**MINUTES**  
**WORCESTER TOWNSHIP PLANNING COMMISSION**  
**WORCESTER TOWNSHIP COMMUNITY HALL**  
**1031 VALLEY FORGE ROAD, WORCESTER, PA 19490**  
**THURSDAY, DECEMBER 14, 2023 - 7:00 PM**

Reference: BT Worcester, LLC – City View Land Development  
Preliminary Plan Review – Third Review

RE: **Traffic Review #5 – Highway Occupancy Permit Plans (PennDOT & County)**  
City View (formerly Fairview) Apartments (2974 W. Germantown Pike) – 180 proposed apartment units  
Worcester Township, Montgomery County, PA  
Project No. 310767-01-001 (formerly 821A37.11)

OFFICES LOCATED IN:  
 CALIFORNIA, INDIANA, KENTUCKY,  
 MASSACHUSETTS, MICHIGAN, NEW JERSEY,  
 OHIO AND PENNSYLVANIA

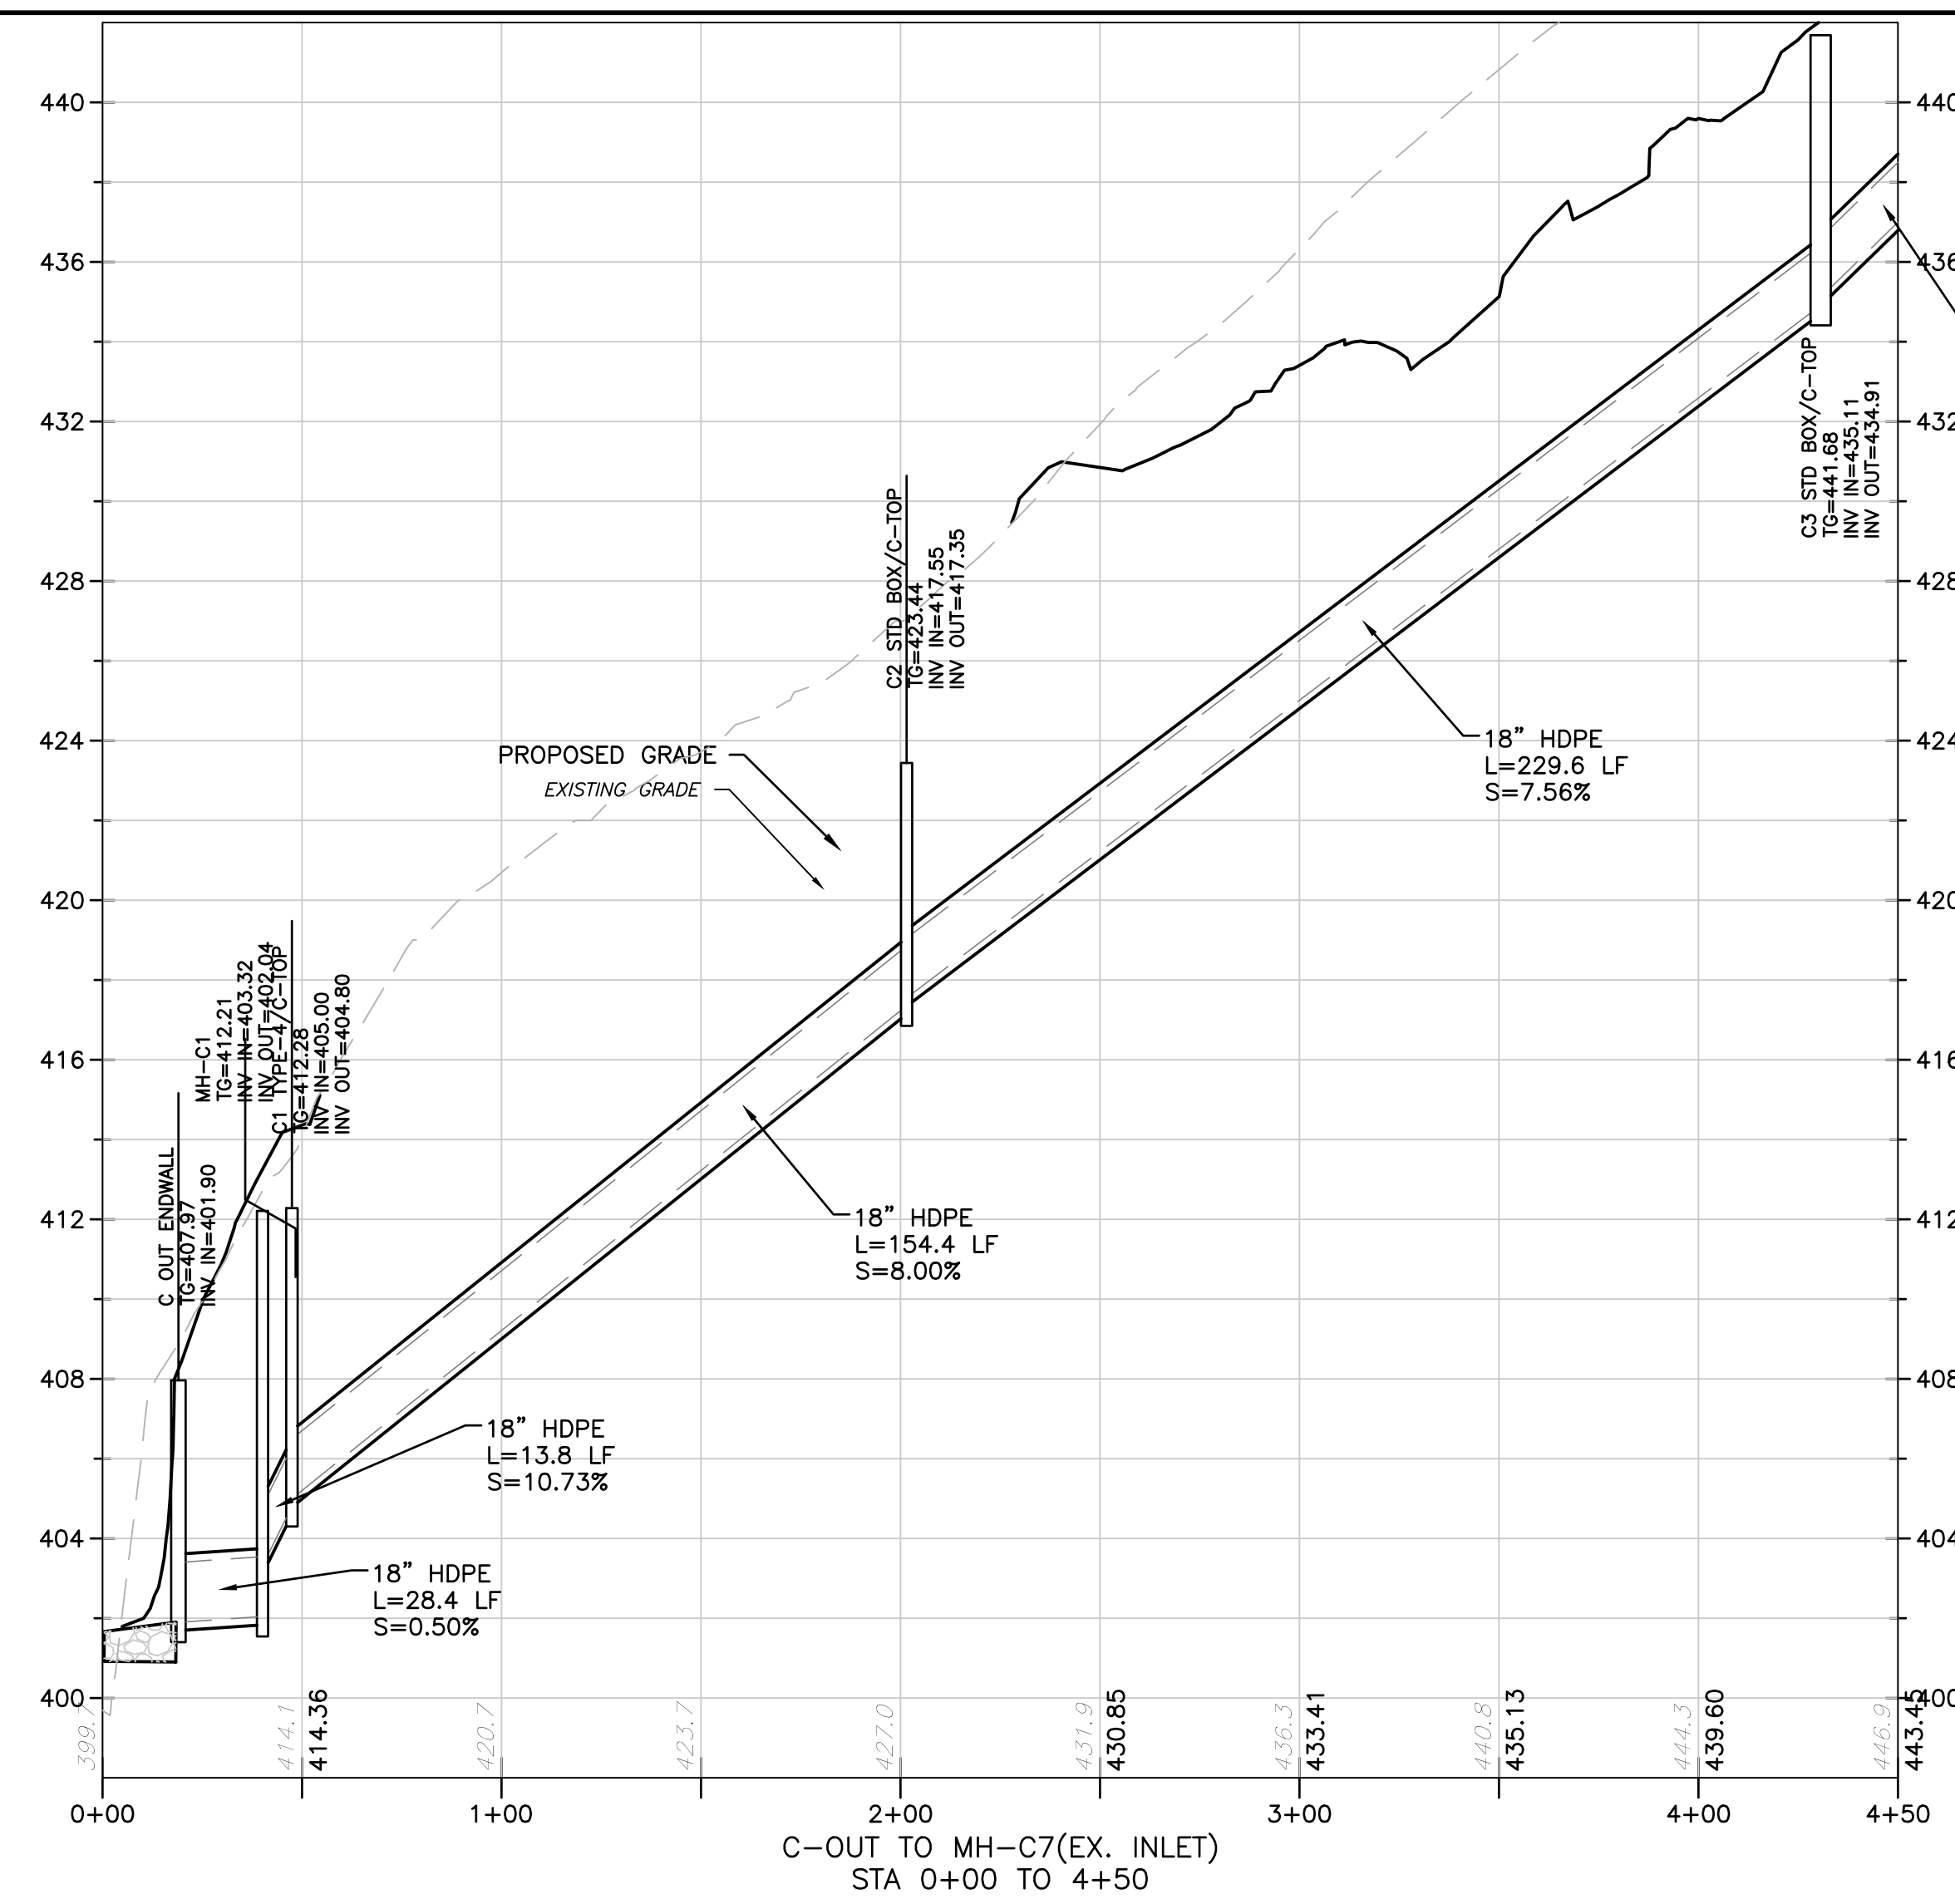
30. A profile of storm sewer B 003 to MH-B1 must be added to the plans.
31. All portions of the basin bottom shall have a minimum slope of 2%. The proposed Basin B appears bottom is flat. The applicant's response states that a waiver will be requested. SMO 129-18.H(10)).
32. A stabilized access drive with an access easement has been shown for Basin B. The engineer's response that indicates Grass Pave Turf Reinforcement has been called out on the plans. This office cannot find this plan reference for the Basin Access Drive. (SMO 129-18-H(22)).

**BLACK VINYL COATED CHAIN LINK FENCE 12" WIDE EMERGENCY GATE DETAIL**  
NOT TO SCALE

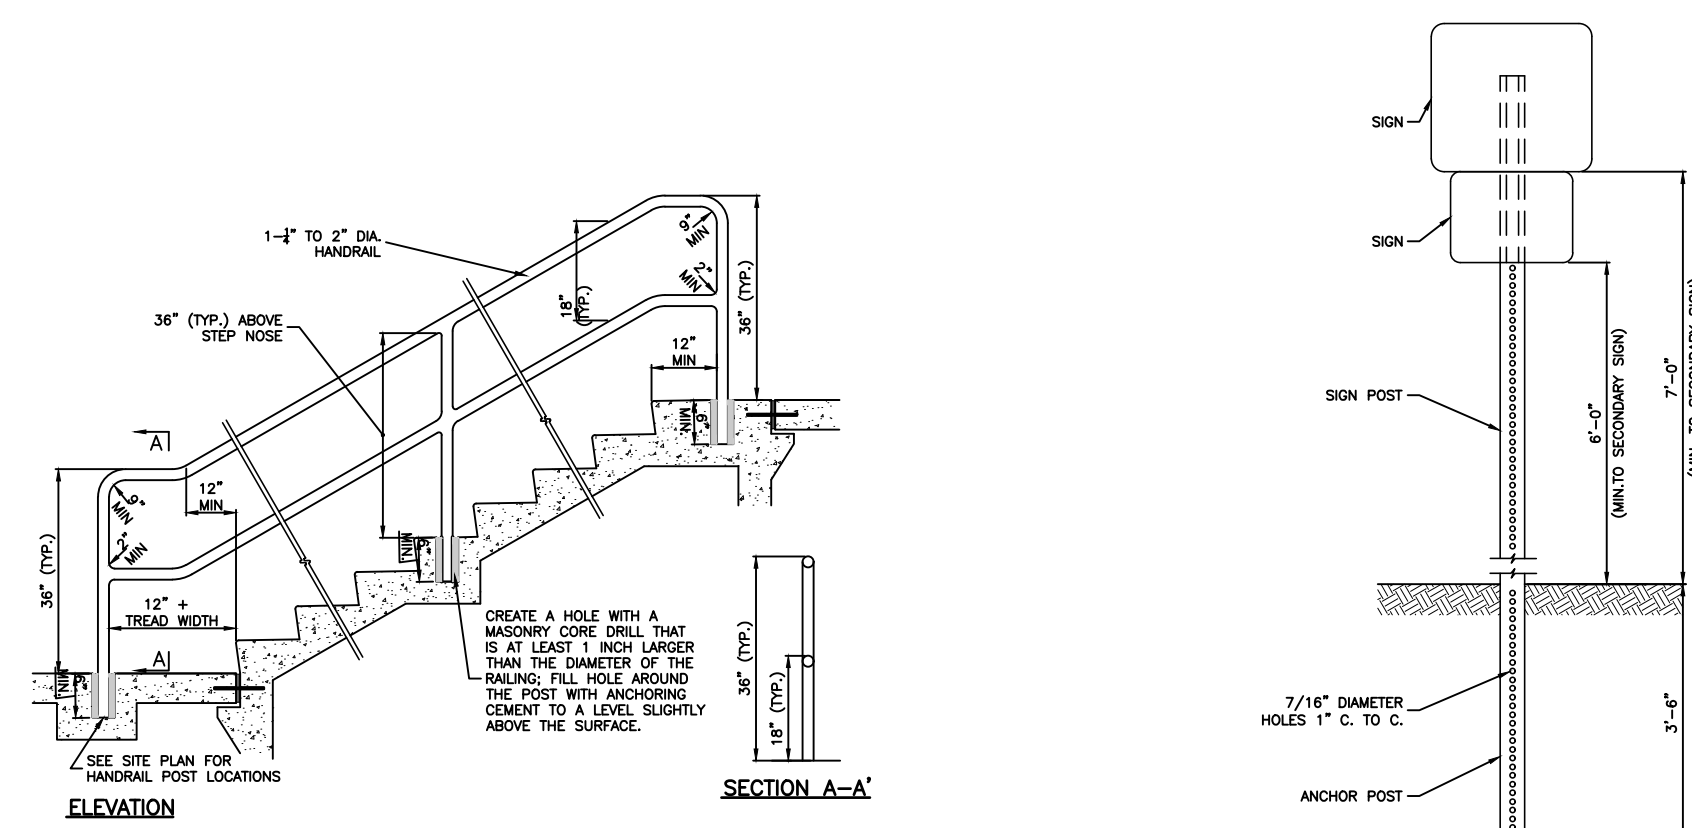
15. A trash enclosure detail is provided on Sheet 21 but the location of the enclosure could not be found on the plans.
16. A 12-foot high Emergency Gate detail is shown on the Sheet 21 but the plans do not indicate 12-foot high fence or gate. Please note that fencing can be no higher than 6-feet per Z.O. 150-182.

PAVEMENT RESTORATION (BITUMINOUS)

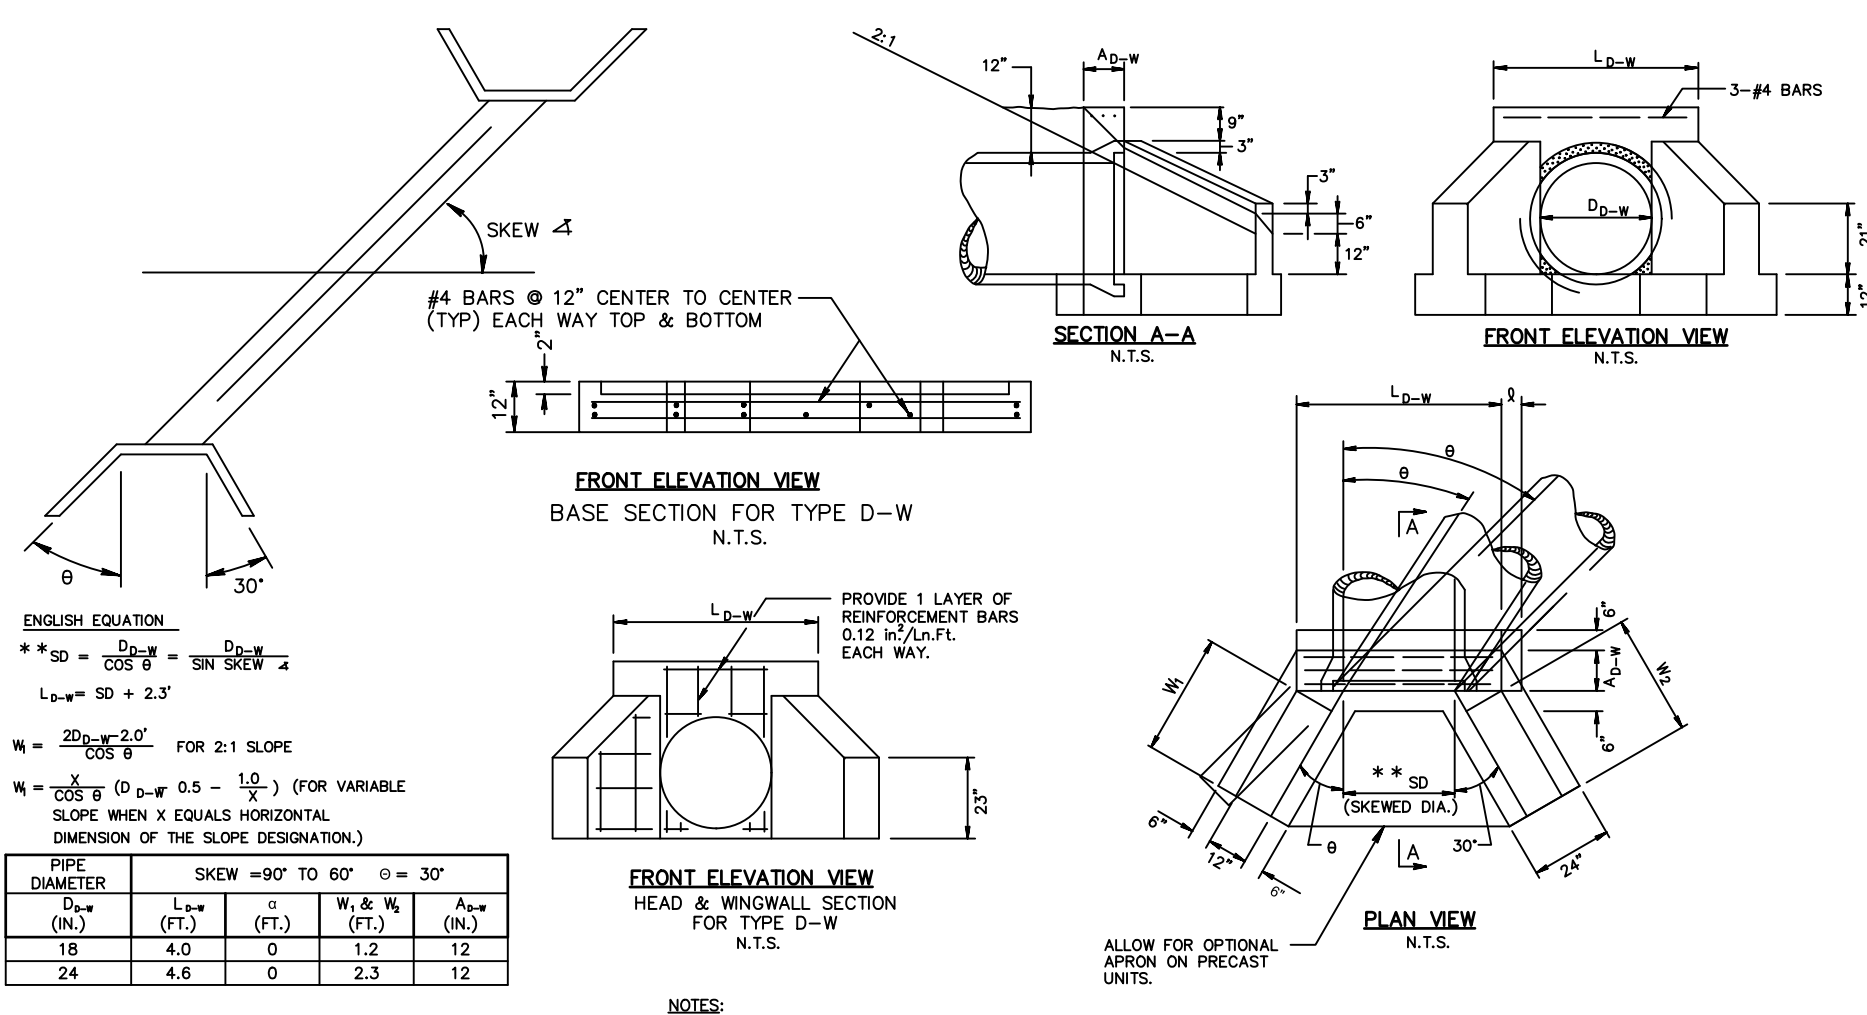
- (1) Revise the base course as follows:
  - Change from PG 64-22 to PG 64S-22
  - Change ESAL range from 0-0.3 million to 10 to <30 million.
